ALERT SERVICE BULLETIN

505-21-23
17 June 2021

SUBJECT: OIL SYSTEM - DEDICATED CRITERIA IN THE FRAME OF BELL ASB 505-21-22

SERVICE BULLETIN No. 319 79 4847

Figure 1 - Machining chips from BELL oil tank

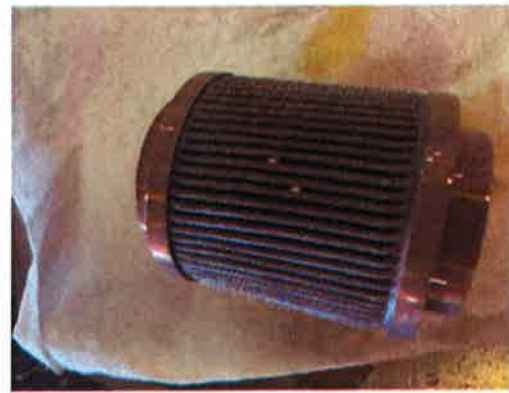
Bell and Safran Helicopter Engines have become aware of a situation on the field regarding particles (Refer to Figure 1) found during a routine engine oil change and filter inspection.

The results of the joint investigation performed by Safran Helicopter Engines and Bell have revealed that most nonmagnetic particles were introduced into the engine oil system via left over manufacturing fragments trapped inside Bell engine oil tanks.

2.6.2.2. If the particles found in the oil filter are similar to Figure 1, Refer to the special decision table below:

Type of particles		Maintenance level		
Wires	Q < 5	Level A Refer to Figure 205	Q ≥ 5	Level B + Particle analysis Refer to Figure 206, Figure 208
Machining chips	Q < 5 30	Level A Refer to Figure 205	Q ≥ 5 30	Level B + Particle analysis Refer to Figure 206, Figure 208
Coked oil	Q < 5	Level A Refer to Figure 205	Q ≥ 5	Level B + Particle analysis Refer to Figure 206, Figure 208
Flakes, Splinters	Q < 2	Level B + Particle analysis Refer to Figure 206, Figure 208	Q ≥ 2	Level C + Particle analysis Refer to Figure 207, Figure 208
Dust (visible to the naked eye)	Q < reference image (1)	Level A Refer to Figure 205	Q ≥ reference image (1)	Level B + Particle analysis Refer to Figure 206, Figure 208
Fragments of the bearing separating cage	Level C Refer to Figure 207 The particles analysis is not necessary			
Non-magnetic particles	Rubber, paint, organic deposit	Level A Refer to Figure 205		
	Silver particles	Level B + Particle analysis Refer to Figure 206, Figure 208
